ADDENDUM TO CONTRACT DOCUMENTS

Date: January 15, 2016
To: Bidders
From: Scott Gordon
Copies: Capital School District
Project: Central Middle School, Repaving Project
Dover, DE
Project Number: BMG Project No. 2015200.00
Subject: **ADDENDUM NO. 1**

Central Middle School Repaving Project
Capital School District
BMG Project No. 2015200.00

ADDENDUM 1
CENTRAL MIDDLE SCHOOL
C-201 - DRAWING CHANGE
211 DELAWARE AVENUE, CITY OF DOVER
KENT COUNTY, DELAWARE

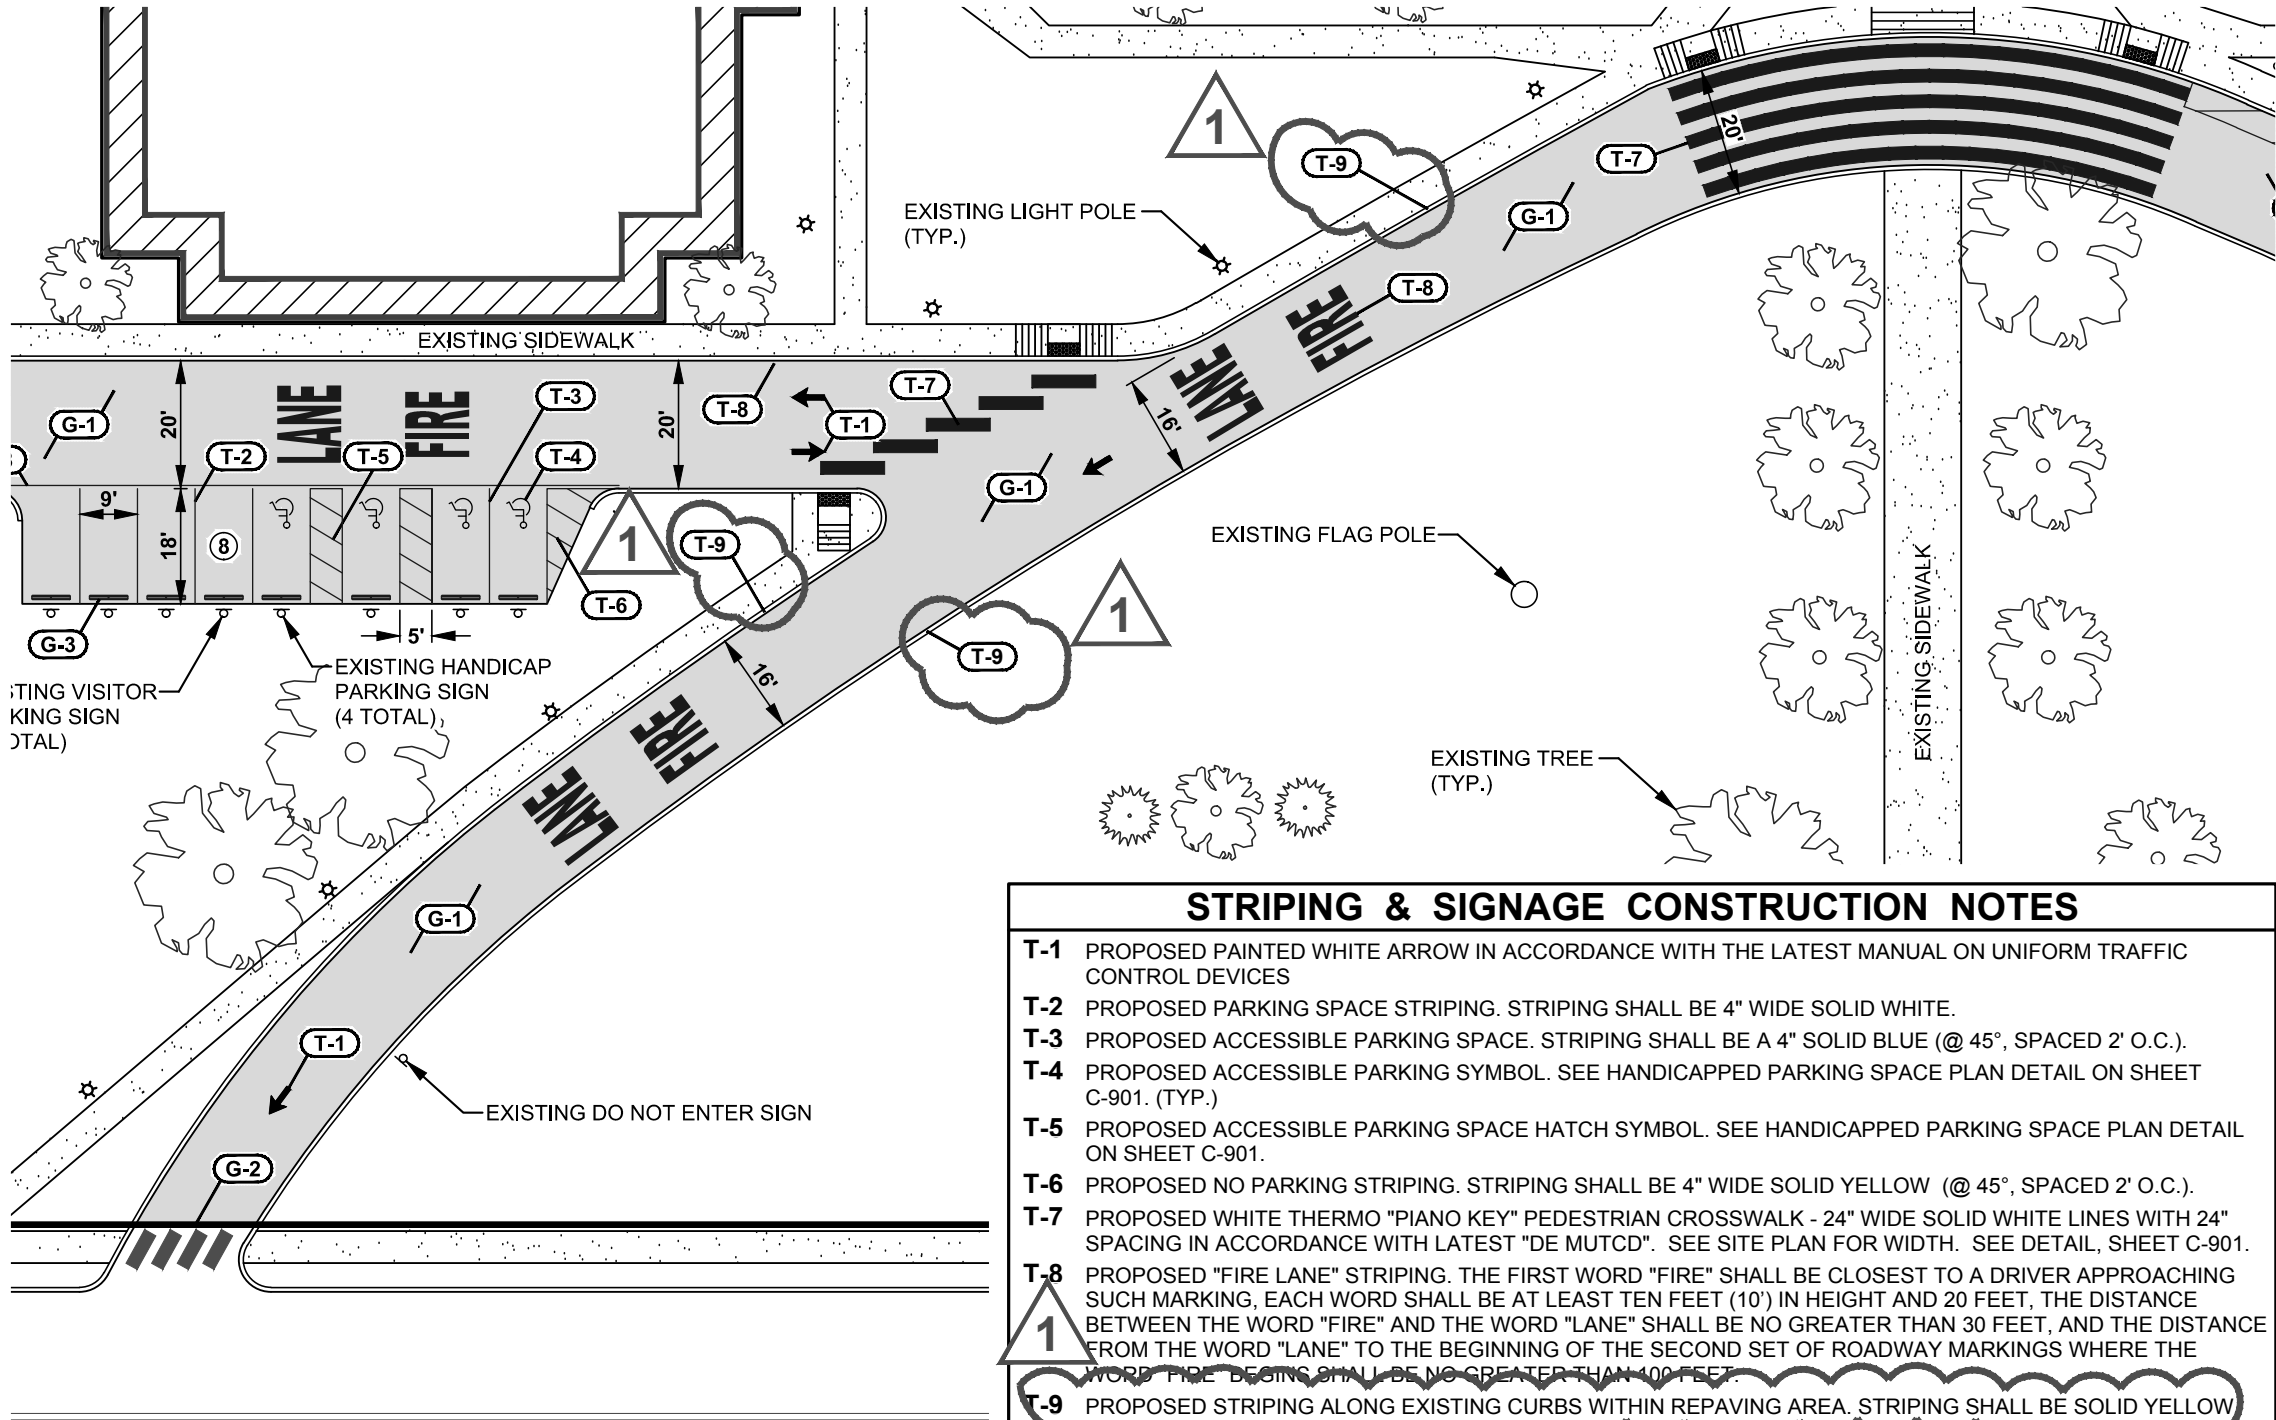
Item	Description
1	C-201; Rotomill & Bituminous Pavement Overlay Plan: <ul style="list-style-type: none">• Revised “Striping & Signage Construction Notes” as shown on attached sketch, CSK001, dated 01/15/16. Added “T-9: Proposed striping along existing curb within repaving area. Striping shall be solid yellow.”

- T-9 PROPOSED STRIPING ALONG EXISTING CURBS WITHIN REPAVING AREA. STRIPING SHALL BE SOLID YELLOW
